September 21, 2026

End of Sale Notice: Spot 2 Device and Magnetic Mount Bracket

Mechanical Comparison — Spot 2 vs. Spot S300

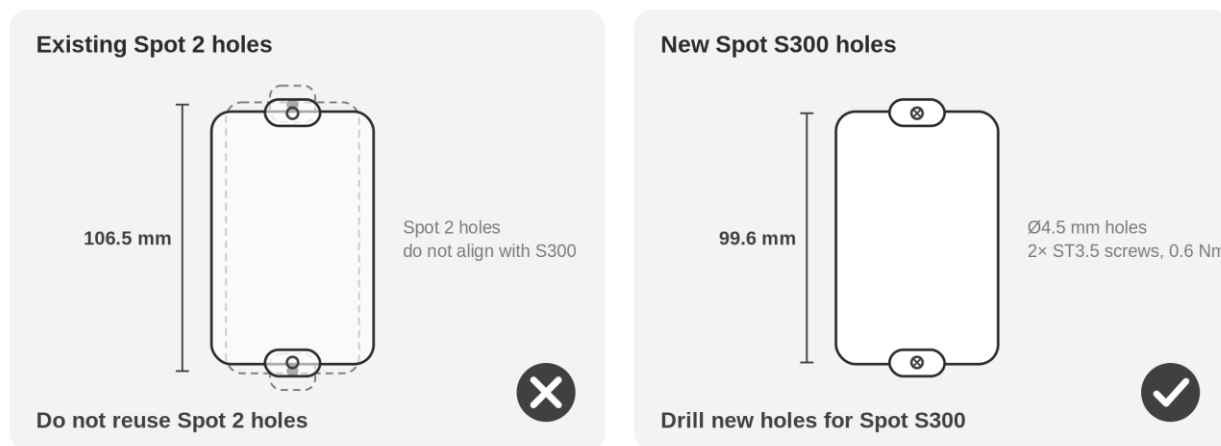
Spot S300 has different dimensions and a different mounting hole pattern than Spot 2 (see below). Spot 2 mounting holes and the Spot 2 Magnetic Mount Bracket (PN 9863.010001) cannot be reused.

Spot 2 mounting holes cannot be reused for Spot S300 — drill new holes to the S300 pattern

Screw-mounted installations: drill new holes to the S300 pattern (99.6 mm center-to-center, Ø4.5 mm). Applies only to screw-mounted devices; torque is unchanged at 0.6 Nm.

Magnet-mounted installations: use the S300 Magnetic Mount Bracket (PN 9863.010002).
